***SECTION 75W MODIFICATION REQUEST
(MP 06_0162 MOD 8)
Barangaroo Concept Plan
Hickson Road, Barangaroo***

Secretary's
Environmental Assessment Report
Section 75W of the
Environmental Planning and Assessment Act 1979

March 2016

Figure 17: Comparison between the height of the proposed podium and existing neighbouring

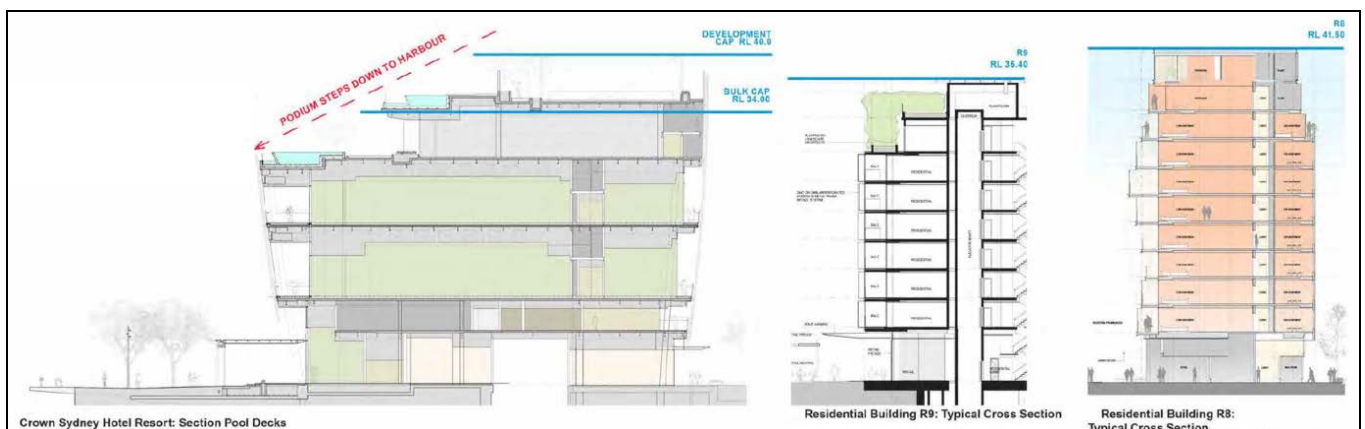
- the proposed western setback from the water's edge is equivalent to the existing setback of the waterfront buildings to the south of Block Y (as discussed in **Section 5.3.2**);
- the assessment of the detailed design of the podium will be the subject of the submitted Crown Sydney Hotel Resort application; and
- the current Crown Sydney Hotel Resort design indicates that the height of the podium steps down towards the promenade, which, when viewed from a pedestrians' perspective, will reduce its perceived bulk and scale.

Figure 19: West elevation of Block Y podium as originally proposed (Source Lend Lease)

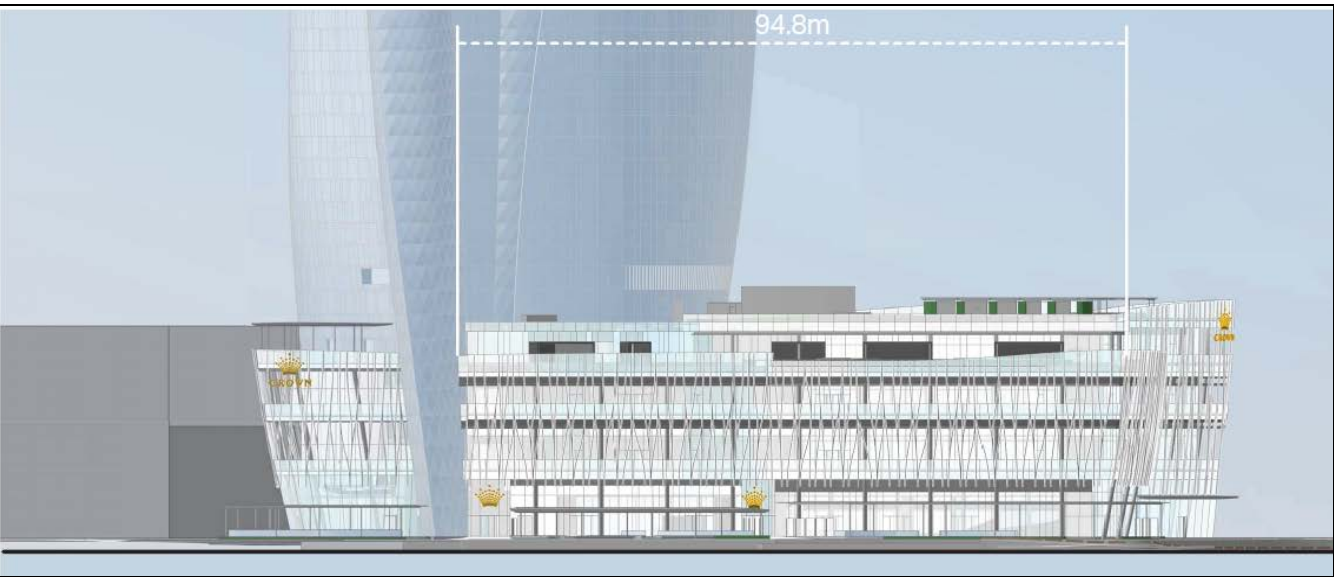
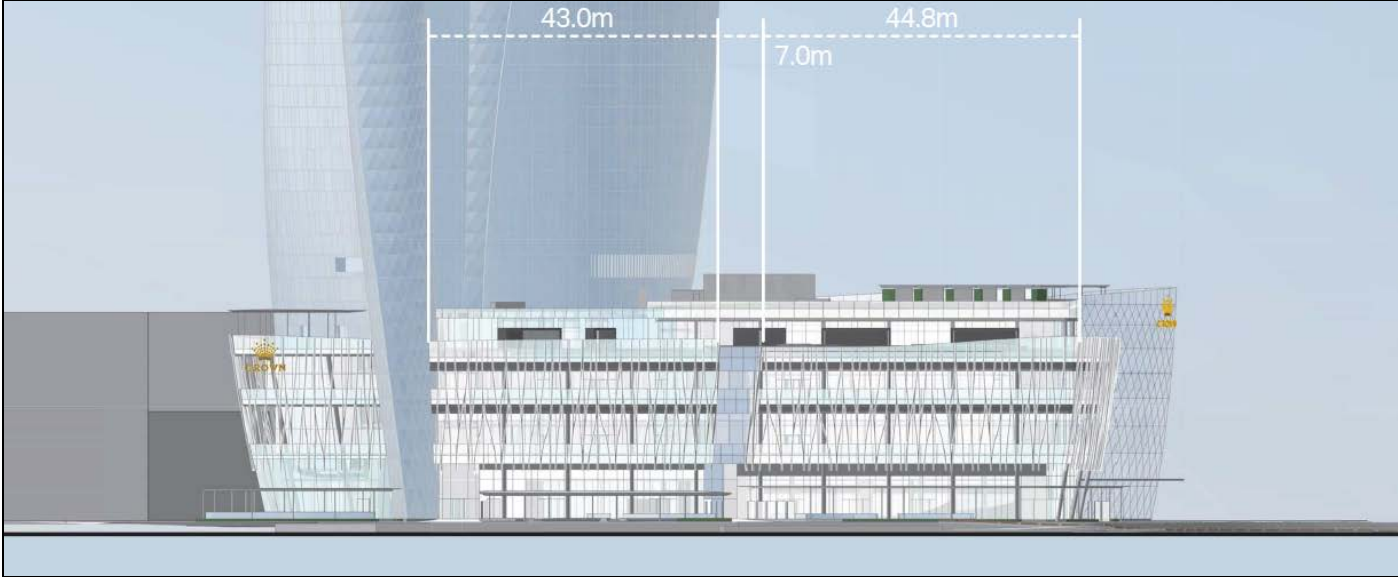
In response, the Proponent submitted amended indicative plans which propose design changes for the podium and surroundings (**Appendix N**). These include a 7 metre recess in the western podium facade in order to segment the podium and reduce its perceived length. As a result, the podium facade will be broken-up into three elements with a maximum unbroken horizontal dimension of 45 metres. The amendments to the indicative design for the western facade of Block Y are illustrated in **Figures 19 to 22** below.

In accordance with the above analysis, the Department recommends modifications requiring the Proponent to submit an amended building envelope drawing detailing the revised setbacks and dimensions relevant to Block Y prior to the determination of any SSD application for above-ground works on Block Y.

Figure 34: Setback of Block Y podium to Watermans Cove as originally proposed/exhibited (Source: Lend Lease)

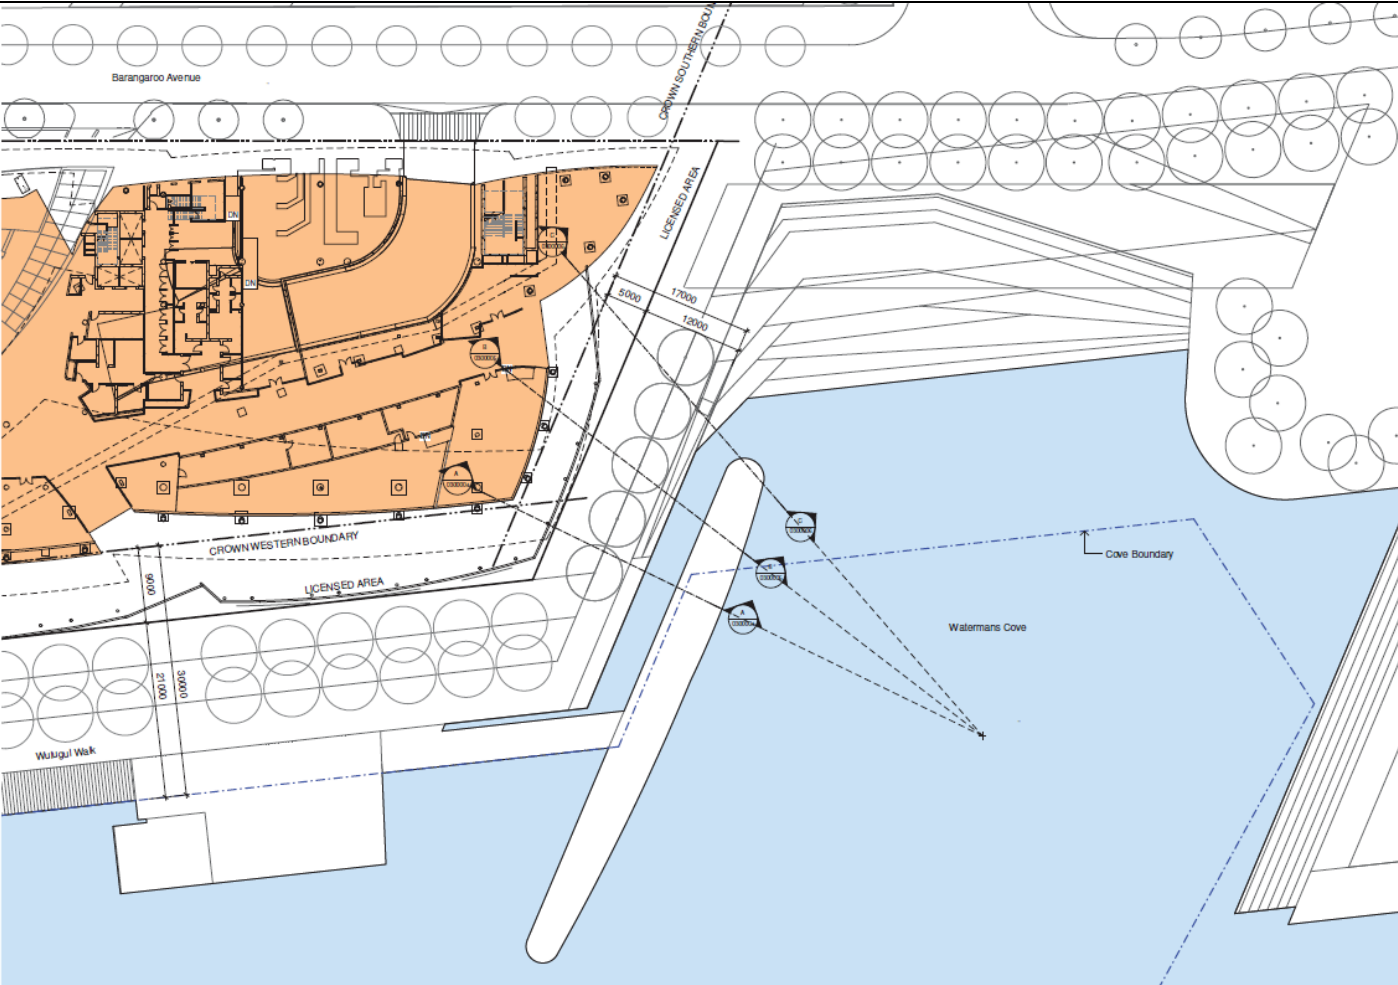
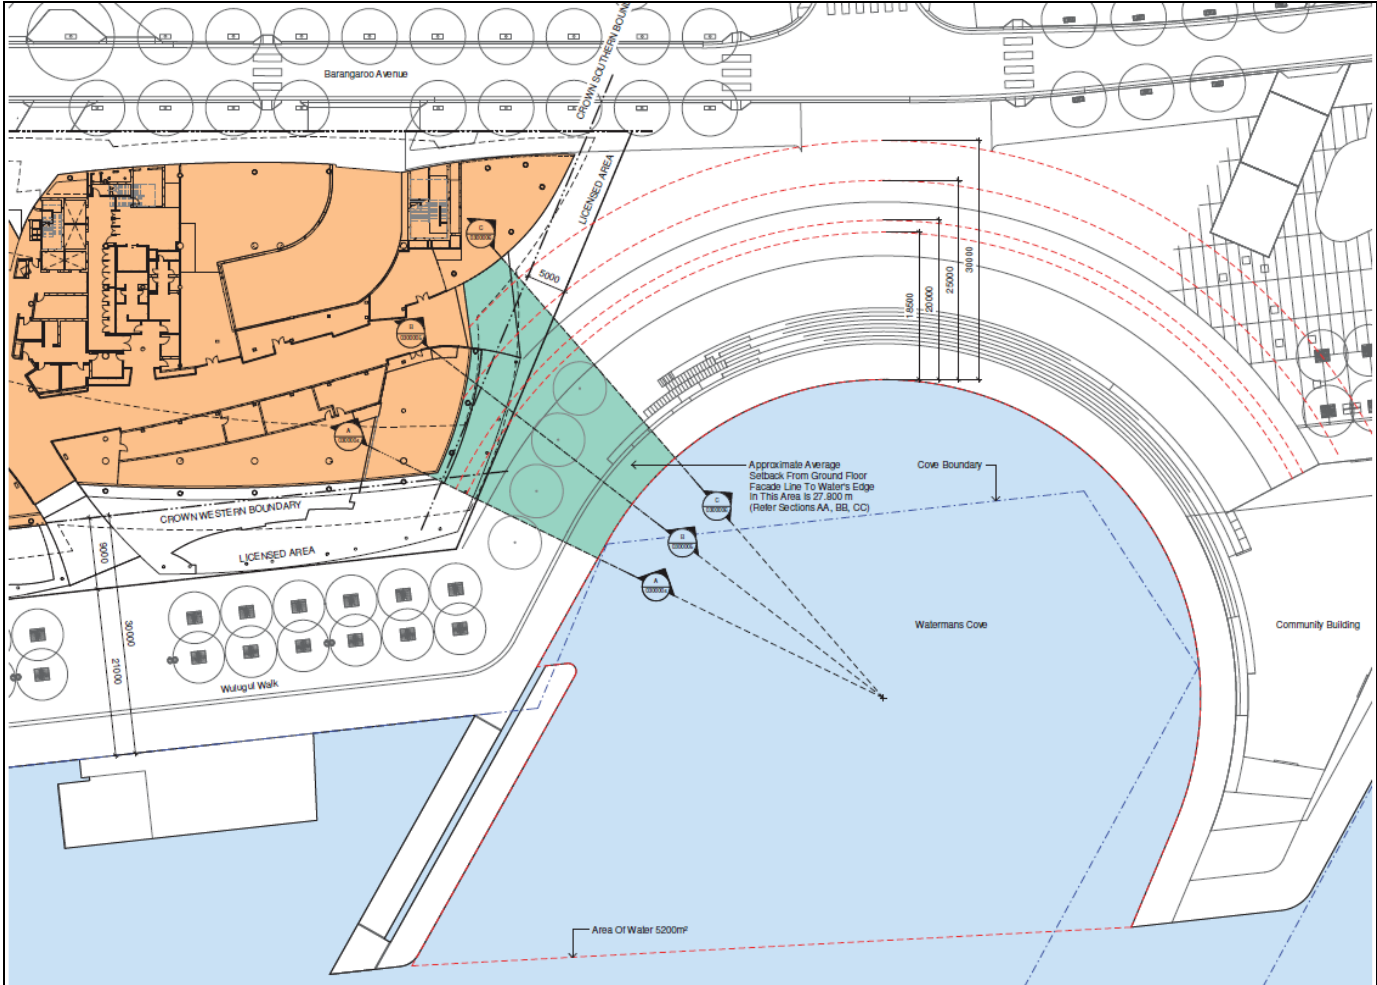
As a result of the above, the design of Watermans Cove would be reconfigured from a rectilinear form to a curvilinear form. Additionally, the promenade would be extended to the south, rather than reducing the extent of the Block Y podium as recommended by the Department (**Section 5.2**). The Proponent proposes an average setback of 27.5 metres could be achieved to the ground floor façade of the podium. These amendments are illustrated in **Figures 35** and **Figure 37**. For comparative purposes, **Figures 34** and **36** illustrate the exhibited form of Watermans Cove.

In light of the above assessment, the Department recommends a modification to the Concept Plan reflecting the enlargement of the Watermans Cove promenade, which should be no less than an average of 27.5 metres to the southern podium façade and 18.5 metres to the outside edge of any vertical structure associated with any licensed area. Further, the Department has recommended that the Proponent submit an amended building envelope drawing detailing the revised layout and dimensions.

Figure 39: Approved unimpeded (top) and proposed obscured (bottom) east/west view corridor through the Concept Plan site (Base source: Proponent's PPR)

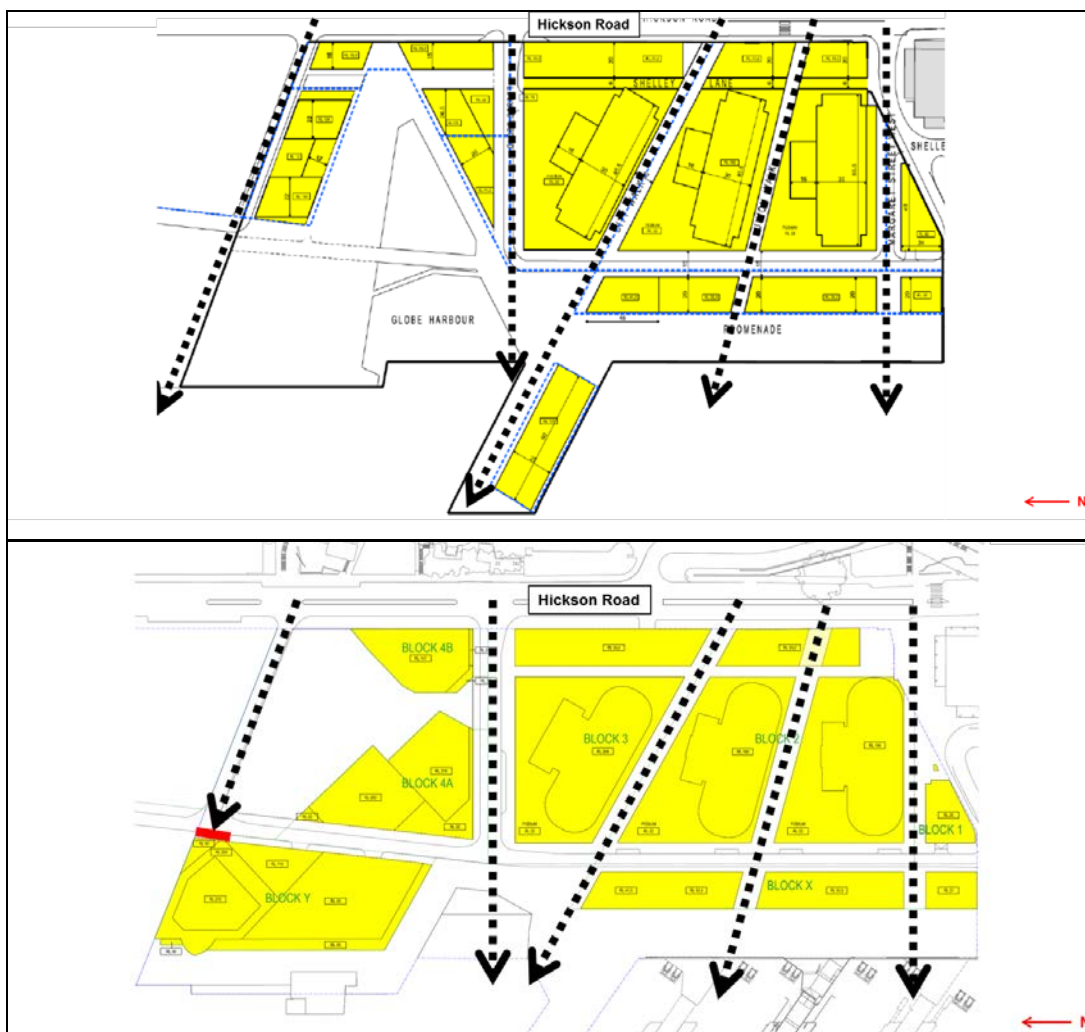
The Department notes that one of the fundamental principles governing the urban form and layout of the Concept Plan is the establishment of unimpeded east/west views from Hickson Road to Darling Harbour along roadways / pedestrian thoroughfares. However, the Department notes that the northern extent of Block Y building envelope extends approximately 12 metres further north than the northern boundary of Hickson Park and this arrangement results in the obstruction of one of these key view corridors as shown in **Figures 39 and 40**.

Figure 41: East/west view corridor to the north of the Northern Park as originally proposed/exhibited (Source Lend Lease)

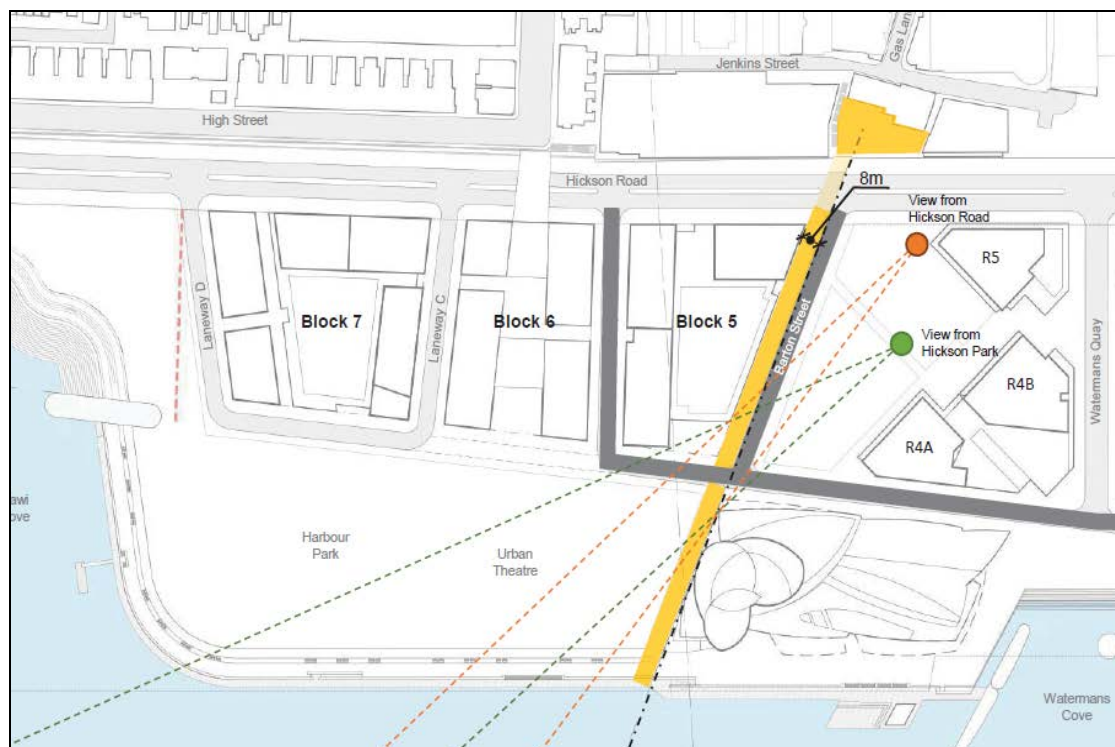
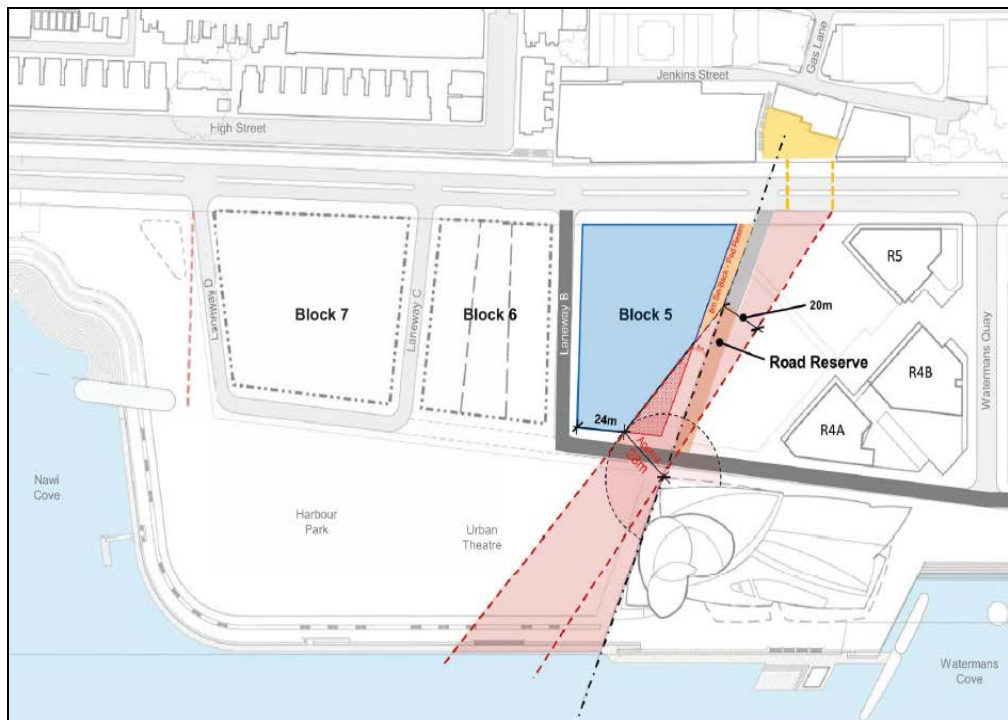
In response, the Proponent submitted an amended design which illustrates how an improved east/west view corridor between Hickson Road and the waterfront could be achieved and in doing so, improve the integration of Hickson Park with the Central Parklands. The Department notes that the design amendment does not reduce the northern extent of Block Y but instead proposes an axial shift in the alignment of the view corridor further to the north of Barangaroo South partially into Block 5, which is located in Barangaroo Central. The proposed amendment to the view corridor is illustrated in **Figures 41-42** below.

The Department has considered the Proponent's revised submission and is satisfied that the alternative design addresses the Department's recommendations (**Figure 41**). However, the Department considers that insufficient information has been submitted at this stage to determine whether allowing the building to project or cantilever above a height of 16 metres would not unduly impede or impact on the quality of the view corridor, including blocking views to the sky. The Department's preliminary view based on the information provided is that it would be difficult to justify any proposal to substantially fill the volume of the cantilever/overhang having regard to achieving the Department's objectives to improve physical and visual connectivity through this part of the site, noting that:

Figure 53: Balmain East – proposed

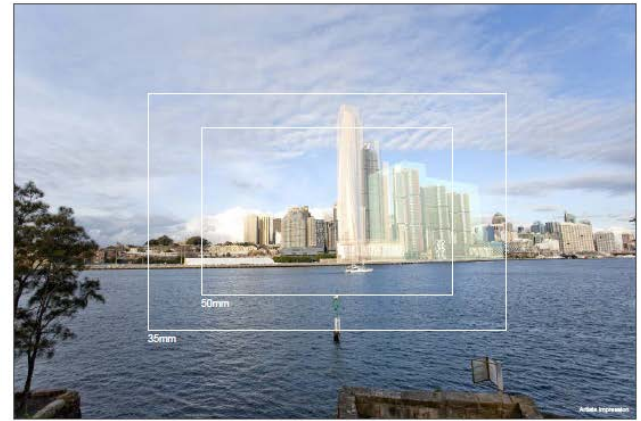
- In regard to views from the west, the Department acknowledges that the full scale and form of the Block Y and Blocks 4A and 4B will be most apparent from these views (**Figure 53**). Furthermore, the Department acknowledges that the location and scale of Block Y will be dominant in views from the south (**Figure 51**). However, the Department considers that the proposal represents an acceptable built form (**Section 5.1**) and acknowledges that the buildings will be refined at the future application stage. Whilst key visual impact resulting from the proposal will be a progressive increase in building height to the north, the Department considers this change to be acceptable in the context of the taller buildings in the CBD and given that the proposal has the potential to contribute a dynamic aesthetic to the existing view experience.

Figure 55: Opera House West Forecourt- proposed

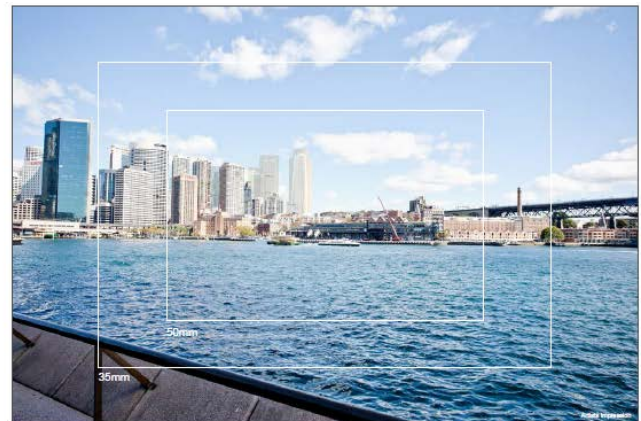
- In regard to views from Sydney Harbour (**Figures 55 and 57**) the proposal will result in a significant change to the city skyline. This will result in the proposal 'bookending' the city skyline and consequently, the proposed building heights will more closely reflect the height of taller CBD buildings to the east, as opposed to retaining the tapered form. The Department considers that this will result in a positive, albeit significant, change to the city skyline.

Figure 64: Classification of wind conditions / pedestrian comfort levels during winter months
(Source: applicant's modification application)

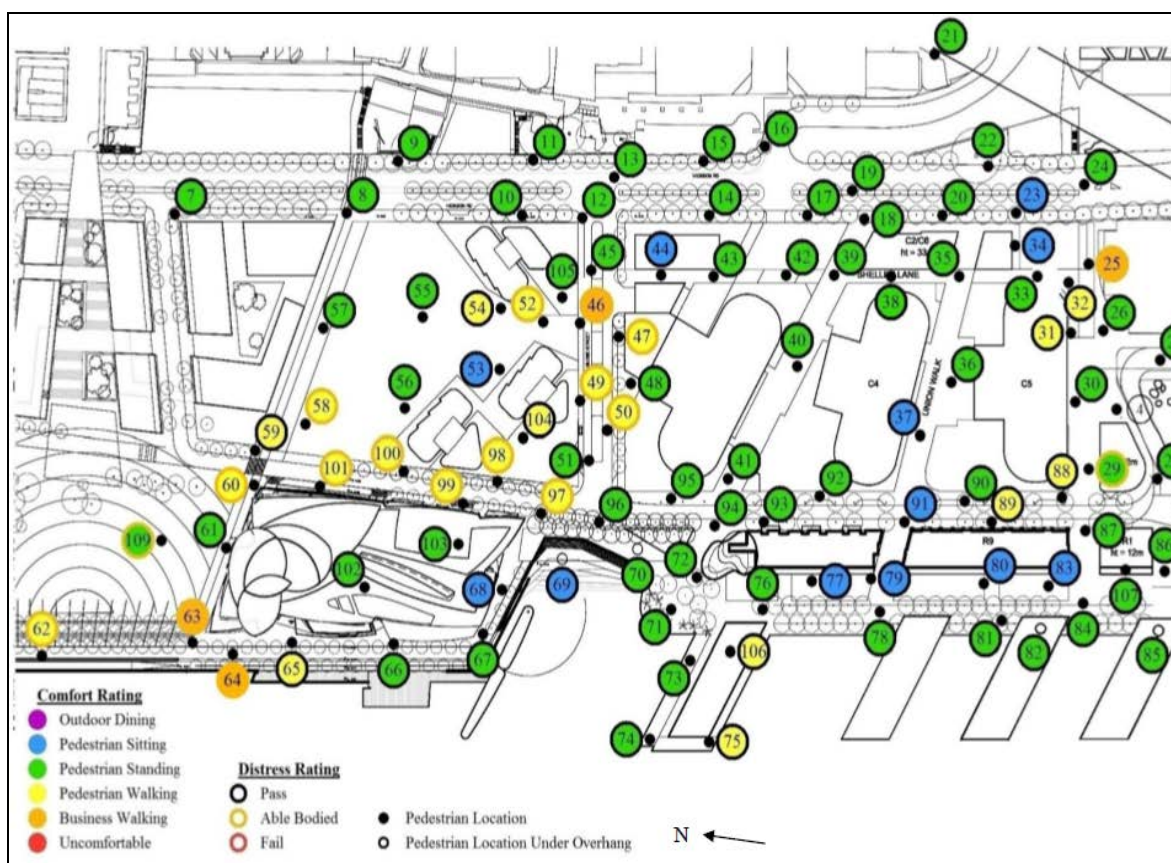
The WIA indicates that from a comfort perspective, the majority of locations around the site are acceptable for pedestrians sitting, standing or walking. However, pedestrians may experience difficulties during windy conditions as shown at the locations noted in **Figure 64**. The WIA has confirmed that the wind environment remains generally consistent with the current approved concept plan and concludes that wind impacts can be suitably mitigated through further site testing and detailed design development to ensure an acceptable pedestrian level wind environment suitable for the intended uses of the site.

Locations 62, 63 and 64 are located at the north-western corner of Block Y (**Figure 64**) and are most exposed to prevailing winds. This area is the windiest part of the Barangaroo site. These locations will be exposed to downwash from Block Y that is accelerating around the north-west corner of Block Y and also by winds from the south being accelerated along the west façade of the tall commercial buildings. Locations 63 and 64 are most affected by these wind conditions and are classified for business walking by abled bodied persons during windy conditions.
